APPLICATION FOR
CONSTRUCTION OF
PAVED
SIDEWALK/ DRIVEWAY

Application No. 11632

SUBSURFACE SEWAGE DISPOSAL SYSTEM & BUILDING SITE PLAN

RE: TB-19-1909

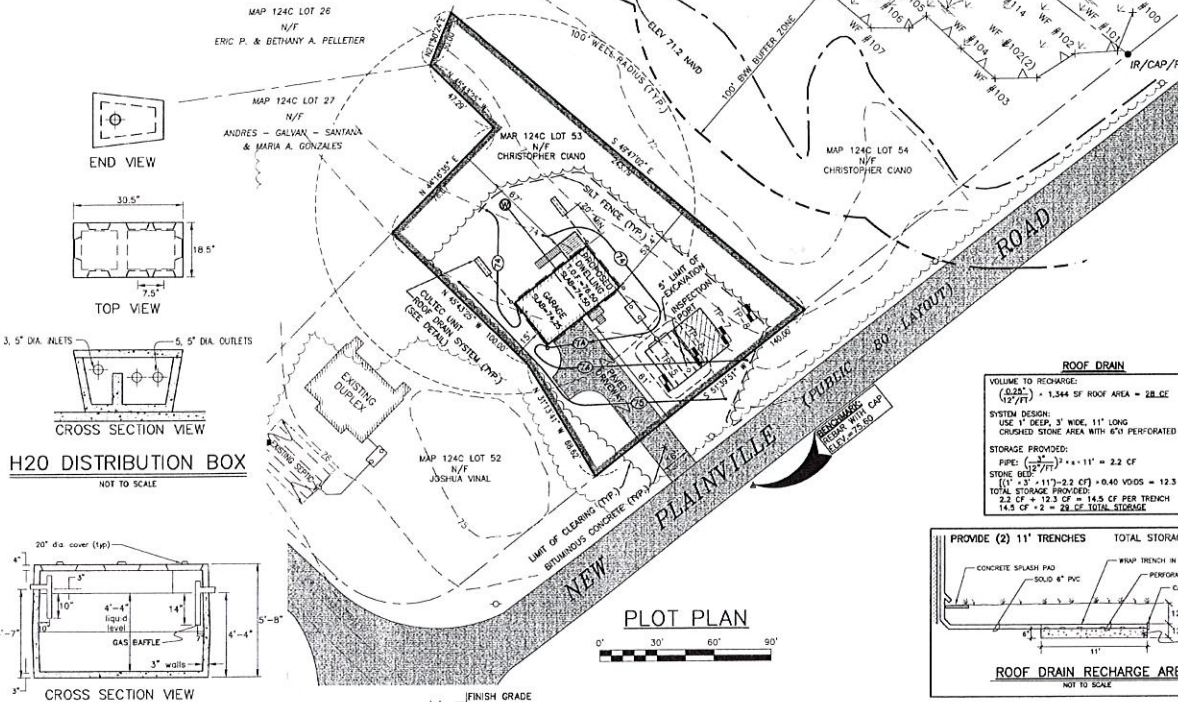
- 1.) The site plan submitted to D.P.I., titled: "Subsurface Sewage Disposal System & Building Site Plan, Owner: Christopher Ciano, Applicant: David Coelho, Assessors Map 124C - Lot 53, New Plainville Road, New Bedford, MA", dated 7/2/2019 (last revised 8/29/2019), as prepared by Sitec, Inc. and stamped/signed by Steven D. Gioiosa, P.E. (Civil), was approved as the "final" site plan, and thus the above foundation permit is being "conditionally" approved by D.P.I., with the following comments:

- a. According to the above plan, the applicant is not proposing to extend the public water to service this dwelling, and there is no public sewer available in the area. However, the applicant must obtain the permits required for the work which falls under D.P.I. jurisdiction, as denoted on this plan.

- b. Must contact D.P.I. to schedule the inspection of the self-contained recharge system. The applicant will be responsible for payment of the final inspection fee.
